DESIGN	DRAWN BY MB	DART AEROSPACE LTD HAWKESBURY, ONTARIO, CANADA
CHECKED	APPROVED	DRAWING NO. DSI 9320 REV. A SHEET 1 OF 1
DATE 06.02.13		TITLE MOVE CENTER CLAMP HOLES SCALE 1:1
A	06.02.13	NEW ISSUE

DART SERVICE INSTRUCTION

TO AMEND INSTALLATION DRAWING D350-578 REV. E
REF. CANADIAN STC SH93-4 ISSUE 7
FAA STC SR00028NY/SR00029NY

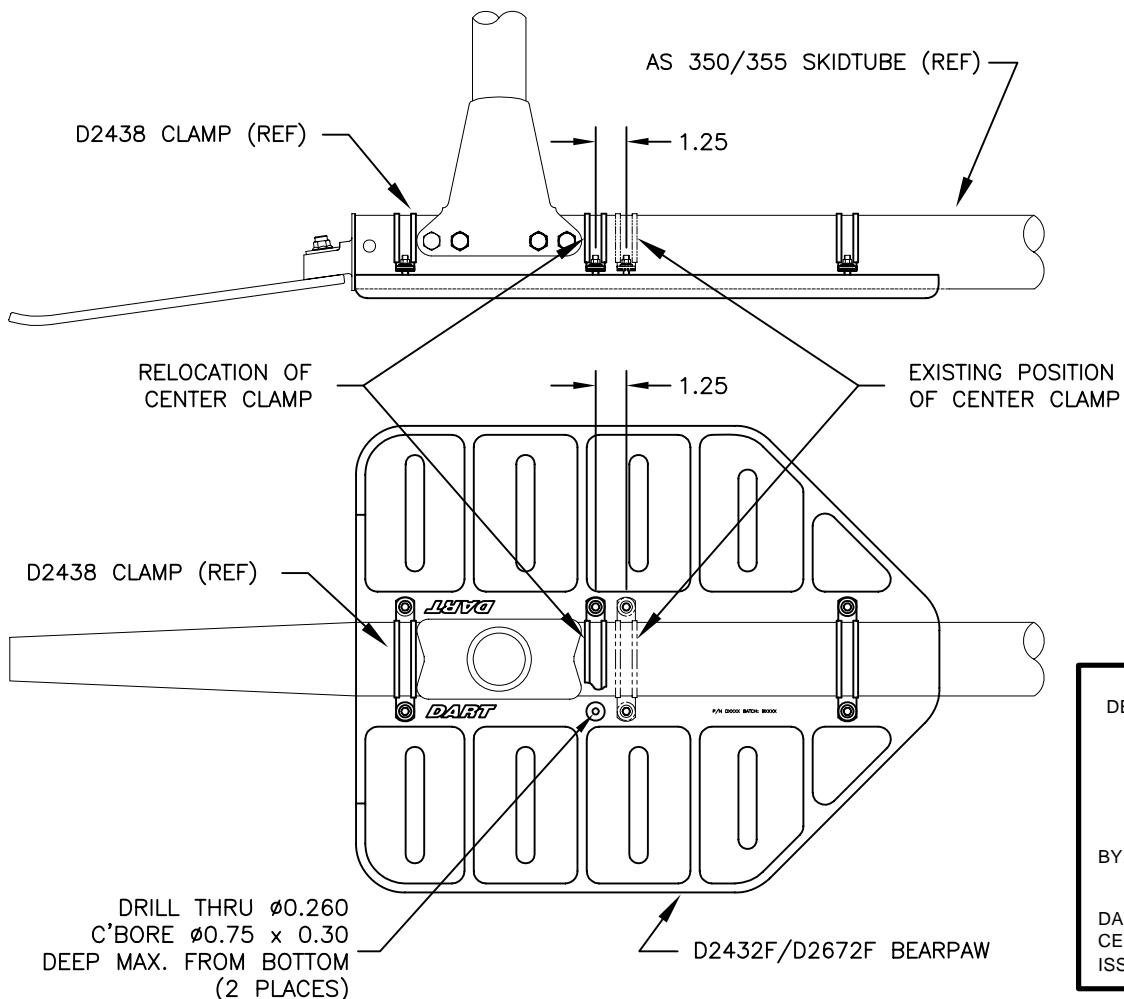
IT IS ACCEPTABLE TO RELOCATE THE CENTER CLAMP ON THE D350-578-011/-021 BEARPAW KITS 1.25" AFT AS SHOWN BELOW FOR COMPATIBILITY WITH SOME KITS. DRILL NEW HOLES TO $\phi 0.260$ " AND COUNTERBORE $\phi 0.75$ " MAXIMUM TO 0.30" MAXIMUM DEPTH ON THE BOTTOM SIDE OF THE BEARPAWS.
